FINAL 2 MARCH 2022

# Bankstown Master Plan Site Specific Review

Joint Panel Report

**Figure 11:** Elevation diagram demonstrating articulation principles to reduce visual bulk, i.e. base, middle and top horizontal articulation and vertical articulation

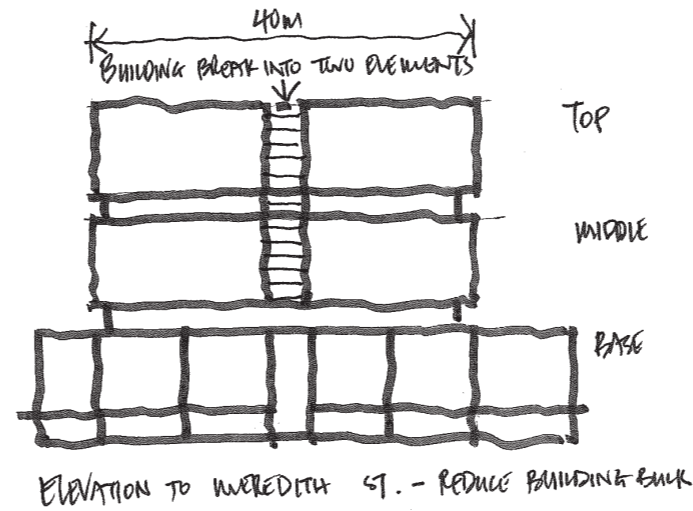
- Consider a rooftop garden on top of the mid-level volume of the building.
- Constrain excavated basement levels for car parking to the area beneath the building footprint, to allow deep soil planting in street setbacks and communal open space.
- Emphasise the corner with distinctive architectural expression.
- Incorporate vertical articulation to reduce visual bulk. Consider a layered built form which defines the base, middle and top of the building with deeper setbacks on certain levels. Refer to Figure 11 and Figure 13.
- Servicing and car parking access should be from Gordon Street only.
- The indicative floor plans indicate privacy and interface issues between some apartments in the mid-levels of the building which will require further design resolution. Refer to Figure 12.

Figure 21: Possible increased ground level setback for north facing street activity and laneway setback as per Tall Buildings Study.

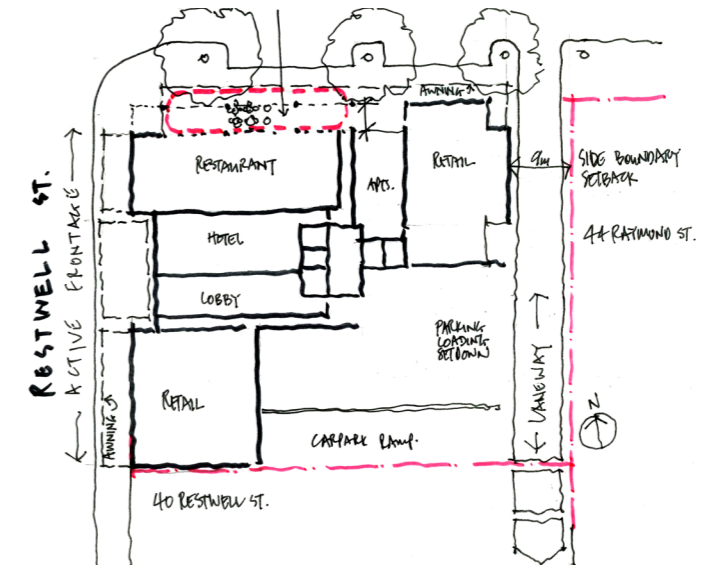
- Provide a minimum 9m setback to tower from the eastern boundary (6m from centreline of a new laneway) and a further 6m setback above 50m (15-16st), to articulate the top of the tower form and consistent with the Tall Building Study. Refer to Figure 21 and Figure 22.
- Protect the key active frontage classification for Restwell Street by removing the vehicle crossing and consolidating all vehicle and service access from Raymond Street, making use of the above 6m laneway.
- Consider an additional 3m setback at ground level of the north elevation (Raymond Street) for improved public benefit with a wider footpath, outdoor dining and greater tree canopy. Refer to Figure 21.

Figure 28: Plan view of simplified building forms

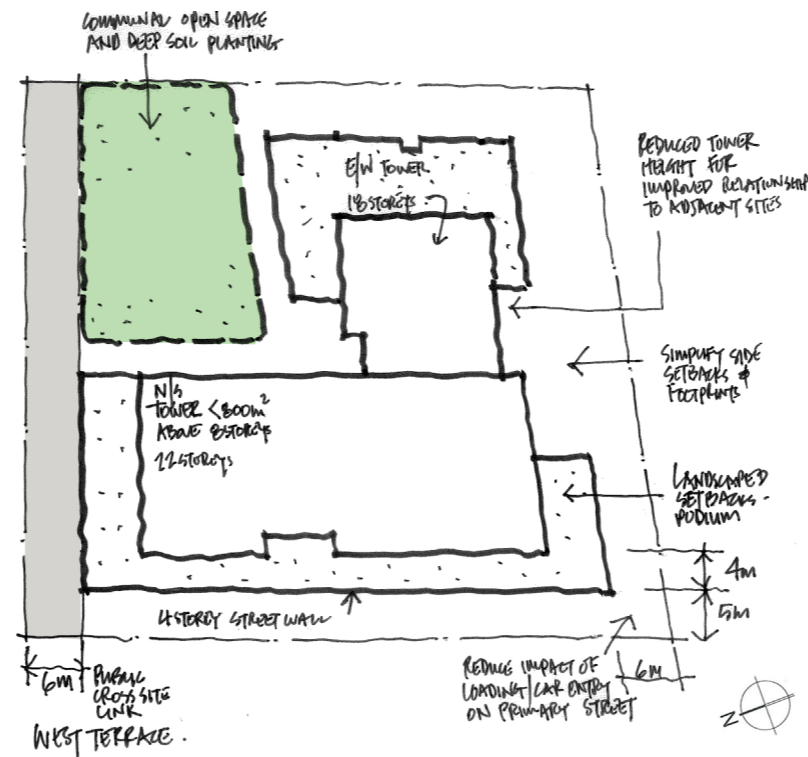
- Simplification of the tower into a single slab or bar building (refer to Figure 28) to resolve amenity issues associated with unit interface and configuration.
- Introduce a lower height for the east wing to articulate the built form, reduce bulk and potential overshadowing of adjacent building and pocket park to south east. Refer to Figure 29.

**Figure 30:** Design development is required to address privacy, amenity, bulk and visual appearance on the eastern elevation

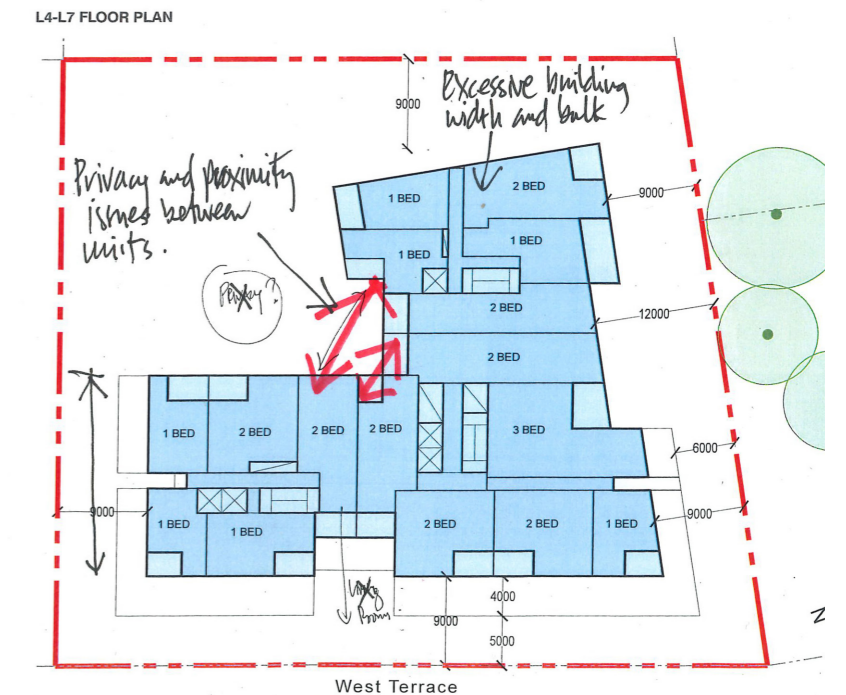
- Deep soil planting must achieve a minimum 7% of the site (283.m<sup>2</sup>) which is not shown in submission and will require some of the currently excavated site to be filled.
- Combined residential and commercial foyers should be separated for improved safety and amenity.

**Figure 39:** Potential to shift northern wing to the east (subject to shadowing impacts) in order to consolidate communal open space

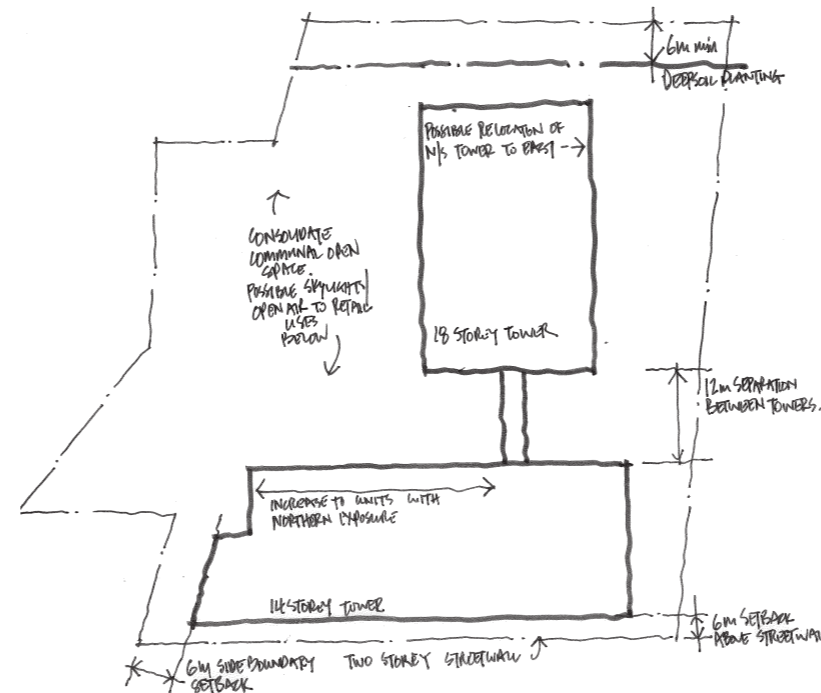
- A lower 14 storey height to the tower fronting Rickard Road. This would:
  - be more compatible with adjacent existing towers along Rickard Road;
  - serve as an appropriate height transition toward Paul Keating Park; and
  - would achieve a 4 storey staggered height to the rear tower to help modulate building bulk.
- Address the excessive building length to Rickard Road with well defined articulation, as indicated in the 3D modelling by the Proponent.

Figure 42: Staggered tower heights (as suggested by Council) are supportable

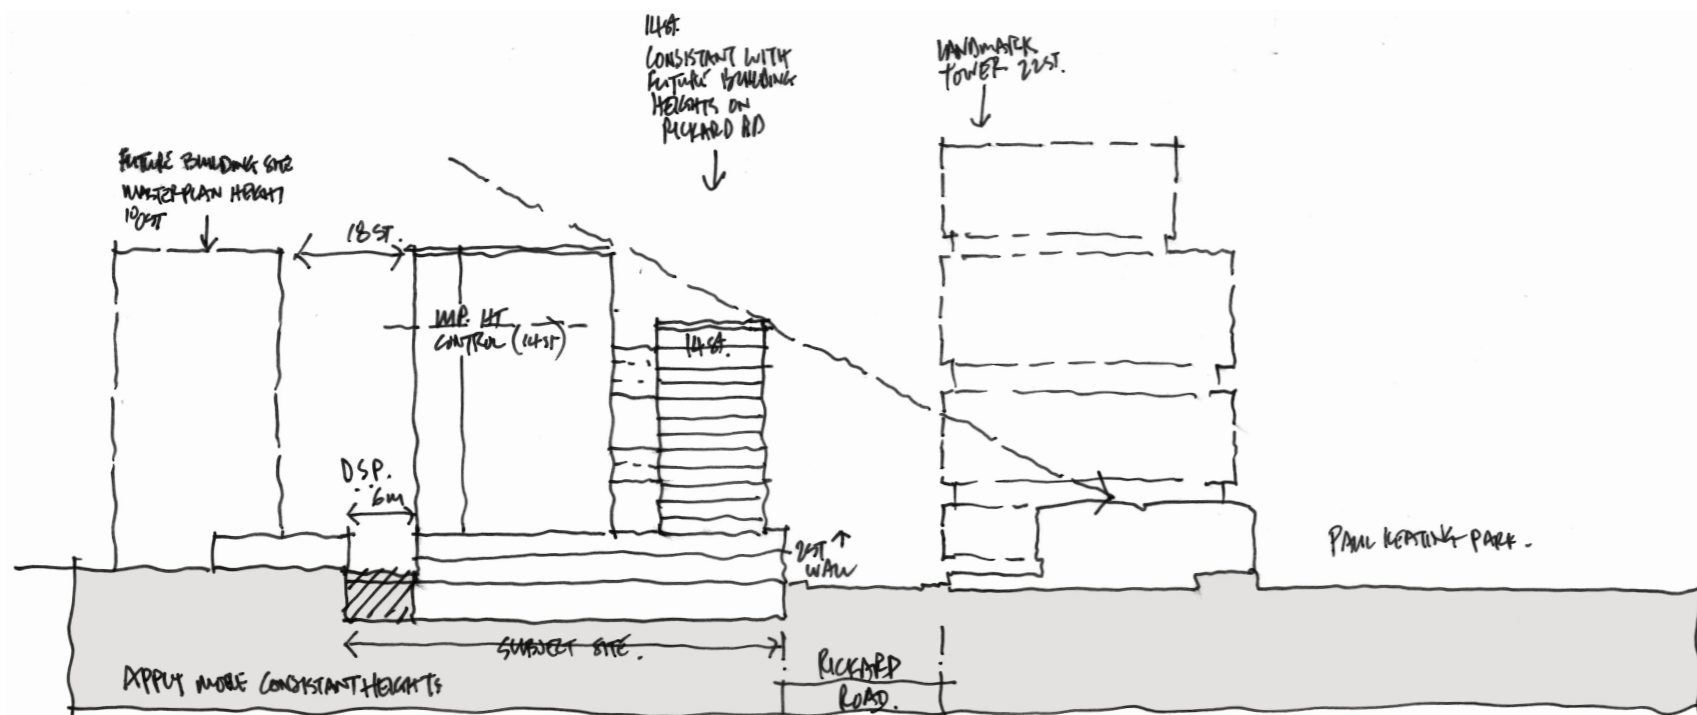
- The shadow analysis submitted by the Proponent demonstrates that the proposed building height of 22 storeys would not result in any additional mid-winter overshadowing of Paul Keating Park, noting that some of the shadowing would fall within shadows cast by the approved WSU Tower. Council has prepared shadow diagrams to verify this.
- However, an overall 18 maximum height is considered to be a better fit with adjacent building heights in the Master Plan. Furthermore, a 14 storey height to Rickard Road is more in keeping with the scale of existing Rickard Road buildings and will allow the WSU tower to be the dominant or signature building in the immediate area.
- The proposed zero side boundary would create a continuous wall effect with the mid-level tower form abutting the existing development to the west. The recommendation for separation between the existing and proposed buildings is

Figure 48: Building height transition diagram

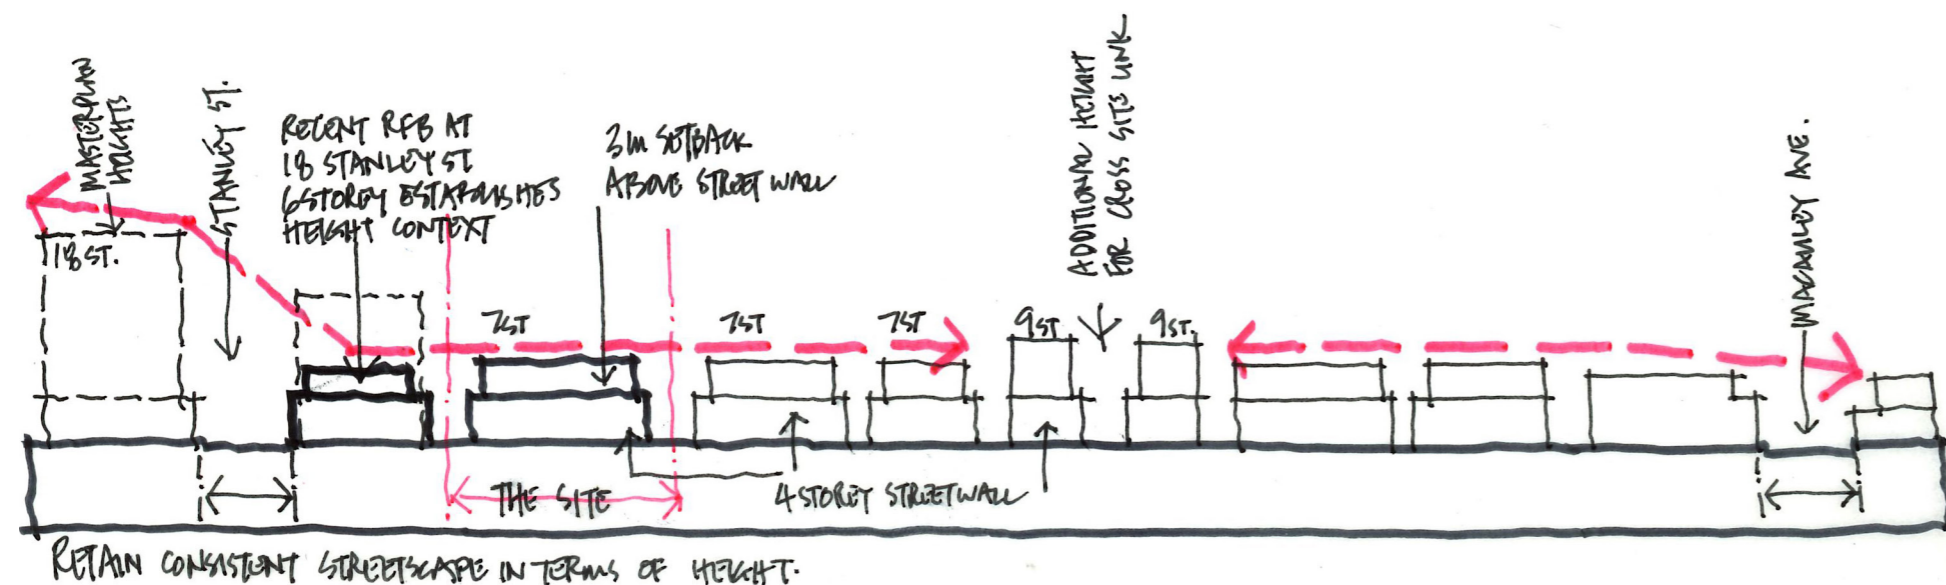
- Retain the 7 storey building height. Refer to Figure 48.
- Retain the 2:1 FSR.
- Allow a consistent 3m upper storey setback along the total length of the amalgamated block.

between the higher 13 and 18 storey Master Plan heights on Stanley Street to the north and the 7 and 6 storey forms to the south. Refer to Figure 48.
